REVISED NOTICE OF HISTORIC REVIEW BOARD DECISION

FILE NO.: MD 17-01, MD 17-02, MD 17-03, MD 17-04, MD 17-05, and MD 17-06:
Historic Review for the designs of six (6) cottage style homes in the Canemah Historic District.

REQUEST: The applicant is requesting design approval for the construction of six (6) new construction cottage style dwelling units, with preservation incentives to adjustment the front, side, and rear setbacks, in the Canemah Historic District.

Proposed House 1:

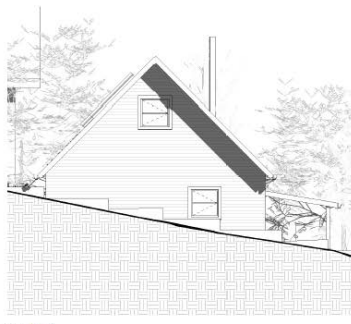
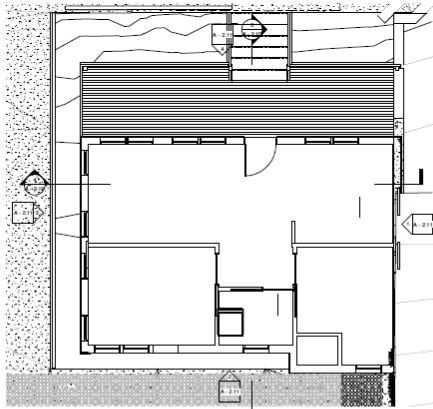
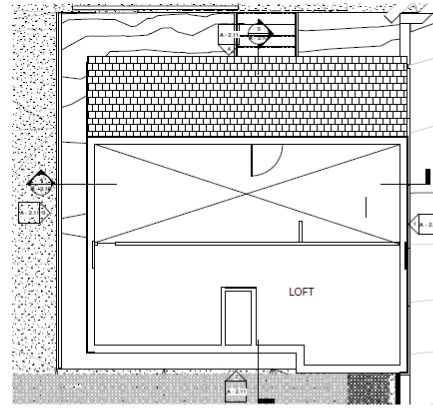
In the design of home number one, the applicant has indicated that they are planning to remove a significant portion of the abutting topography, creating a cutout for the home and a twelve (12) foot wide driveway on the existing lot. This home will also be located directly upon the east property line.

The proposed landscaping in front of the front of the home is unclear. The applicant will need to go through Geotechnical Review along with Site Plan and Design Review.

- Skylights shall be installed in inconspicuous roof slopes and skylights shall be mounted close to the roof plane, and not visible from the right-of-way.

- a. The house shall be repositioned on the site so the proposed home meets the setback standards of the underlying zoning district.
- b. Retaining and structural walls shall be minimized; to be faced or finished in stone, mortared basalt, or concrete, and not exceed 3 ½ feet, to complement the Canemah Neighborhood.

- c. Concrete foundations shall have a natural, parged or painted finish.
- d. Exposed foundations shall be site screened with vegetation if concrete or masonry exceeds 3½ feet, or if pilings or posts are 1½ feet above grade.

- e. A minimum of 5 shrubs and groundcover shall be installed along the façade of the front porch.
- f. Roofing shall use traditional materials such as wood shingles, composition, and metal shingles.

- g. Skylights shall be installed in inconspicuous roof slopes and skylights shall be mounted close to the roof plane, and not visible from the right-of-way.

Proposed House 2:

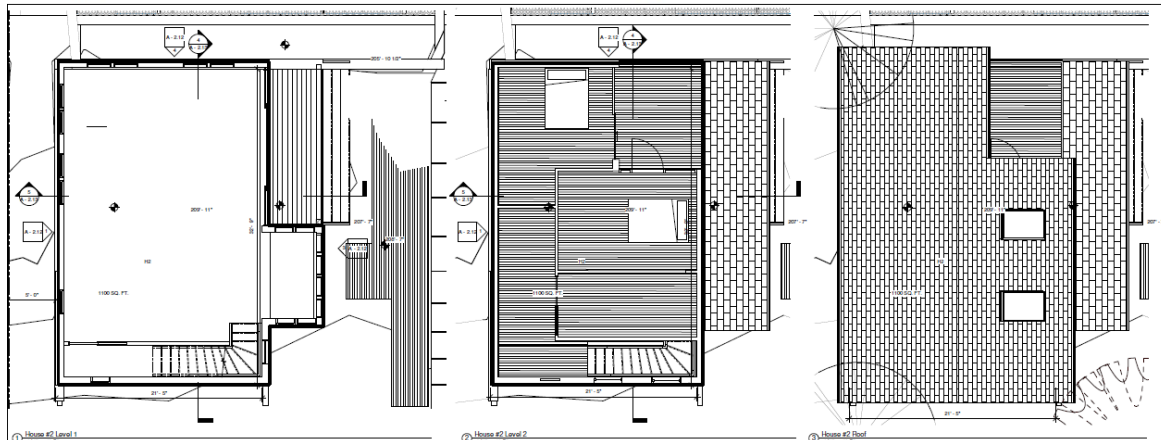
2. House number #2 on the submitted site plan shall be removed from the site, and the proposed cottage home development shall consist of five (5) cottages total. (P)

- a. House #2 shall be removed from the Cottage House Historic Review Board Design Application.

Proposed House 3:

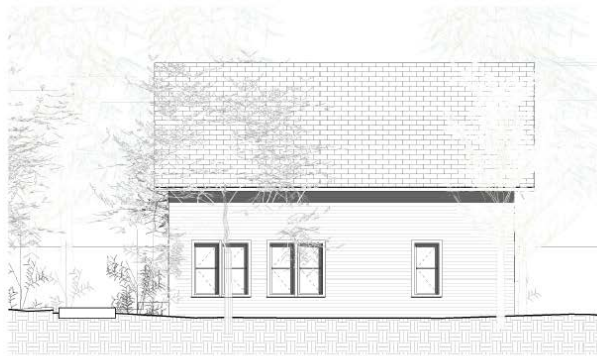
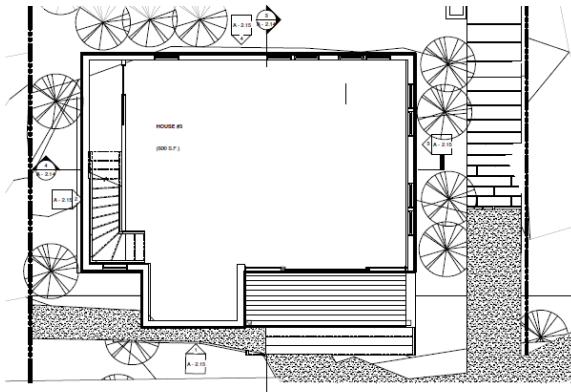
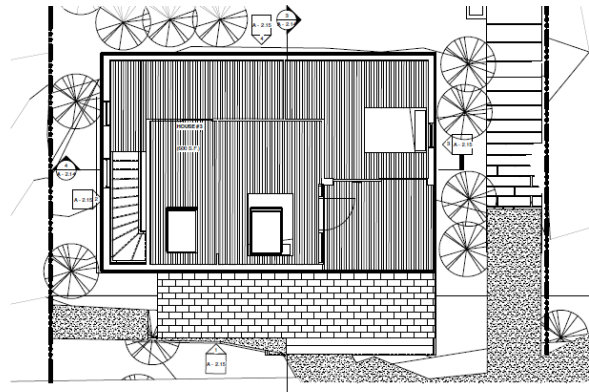
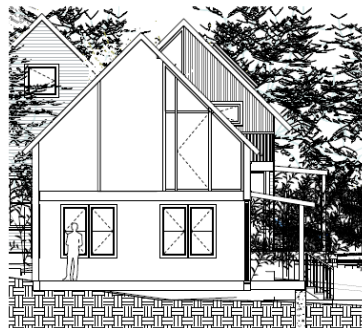
- Roofing shall use traditional materials such as wood shingles, composition, and metal shingles.
- Skylights shall be installed in inconspicuous roof slopes and skylights shall be mounted close to the roof plane, and not visible from the right-of-way.

Staff has determined that it is possible, likely and reasonable that the applicant can meet this standard through the Conditions of Approval.

- a. Primary residential doors shall complement the design and detailing of the historic style with similar appearance to wood. Doors shall be designed in a stile and rail type; panel design; with upper portion glass. The primary door may be a solid panel door. Sliding doors are not permitted.

- b. Gable roof slopes shall have equal pitch. Gable primary roofs shall have a pitch of 8:12 or greater (6:12 for Bungalow). Porch or bay roofs may have lower slope, may have hip if style allows. Roofs shall have a minimum 1 foot overhang with a maximum of 3 feet.

- c. Windows shall match the member sizing, thickness and shadowline of painted wood windows. Windows shall also consist of the following designs: double, single hung, or casement. Wood clad shall be matching in color and finish. Non-wood fiberglass and aluminum windows are acceptable if in appropriate style, and matching wood in profile, shadowline, and if similar in color and finish. If a non-wood style is proposed, a sample is required to be approved by the Historic Review Board.

- d. Concrete foundations shall have a natural, parged or painted finish.
- e. Exposed foundations shall be site screened with vegetation if concrete or masonry exceeds 3½ feet, or if pilings or posts are 1½ feet above grade.

- f. Roofing shall use traditional materials such as wood shingles, composition, and metal shingles.
- g. Skylights shall be installed in inconspicuous roof slopes and skylights shall be mounted close to the roof plane, and not visible from the right-of-way.

Proposed House 4:

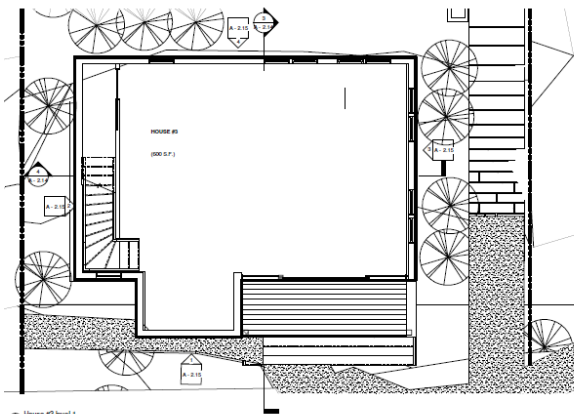
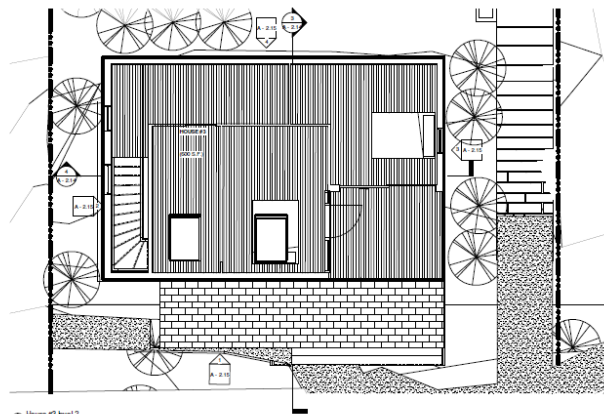
- Roofing shall use traditional materials such as wood shingles, composition, and metal shingles.
- Skylights shall be installed in inconspicuous roof slopes and skylights shall be mounted close to the roof plane, and not visible from the right-of-way.

- a. The main entrance of the house shall not be oriented towards the adjacent parking lot.
- b. Windows shall match the member sizing, thickness and shadowline of painted wood windows. Windows shall also consist of the following designs: double, single hung, or casement. Wood clad shall be matching in color and finish. Non-wood fiberglass and aluminum windows are acceptable if in appropriate style, and matching wood in profile, shadowline, and if similar in color and finish. If a non-wood style is proposed, a sample is required to be approved by the Historic Review Board.

- c. Residential doors shall complement the design and detailing of the historic style with similar appearance to wood. Doors shall be designed in a stile and rail type; panel design; with upper portion glass. The primary door may be a solid panel door. Sliding doors are not permitted on any portion of the house.

- d. Concrete foundations shall have a natural, parged or painted finish.
- e. Exposed foundations shall be site screened with vegetation if concrete or masonry exceeds 3½ feet, or if pilings or posts are 1½ feet above grade.

- f. Roofing shall use traditional materials such as wood shingles, composition, and metal shingles.
- g. Skylights shall be installed in inconspicuous roof slopes and skylights shall be mounted close to the roof plane, and not visible from the right-of-way.

House 6:

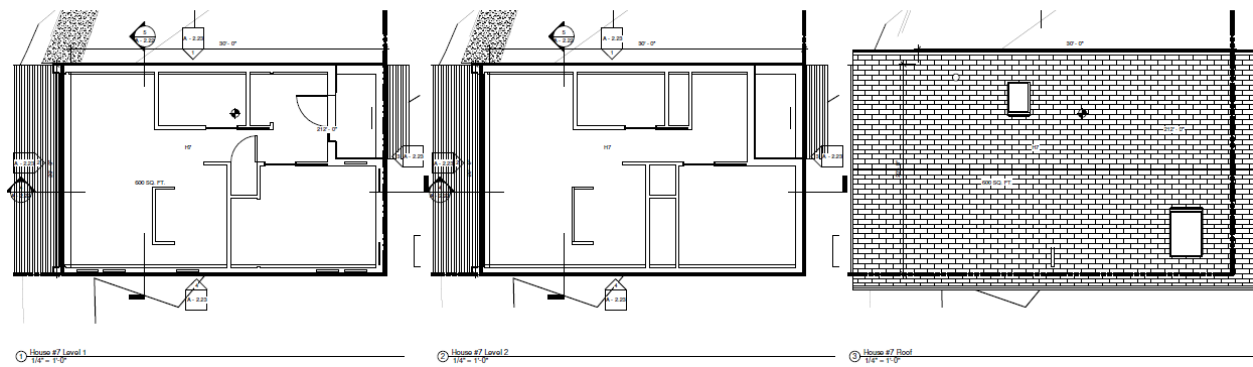
- Roofing shall use traditional materials such as wood shingles, composition, and metal shingles.
- Skylights shall be installed in inconspicuous roof slopes and skylights shall be mounted close to the roof plane, and not visible from the right-of-way.

- a. Residential doors shall complement the design and detailing of the historic style with similar appearance to wood. Doors shall be designed in a stile and rail type; panel design; with upper portion glass. The primary door may be a solid panel door. Sliding doors are not permitted on any portion of the house.

- b. Windows shall match the member sizing, thickness and shadowline of painted wood windows. Windows shall also consist of the following designs: double, single hung, or casement. Wood clad shall be matching in color and finish. Non-wood fiberglass and aluminum windows are acceptable if in appropriate style, and matching wood in profile, shadowline, and if similar in color and finish. If a non-wood style is proposed, a sample is required to be approved by the Historic Review Board.

- c. Gable roof slopes shall have equal pitch. Gable primary roofs shall have a pitch of 8:12 or greater (6:12 for Bungalow). Porch or bay roofs may have lower slope, may have hip if style allows. Roofs shall have a minimum 1 foot overhang with a maximum of 3 feet.

- d. Concrete foundations shall have a natural, parged or painted finish.
- e. Exposed foundations shall be site screened with vegetation if concrete or masonry exceeds 3½ feet, or if pilings or posts are 1½ feet above grade.

- f. Roofing shall use traditional materials such as wood shingles, composition, and metal shingles.
- a. Skylights shall be installed in inconspicuous roof slopes and skylights shall be mounted close to the roof plane, and not visible from the right-of-way.
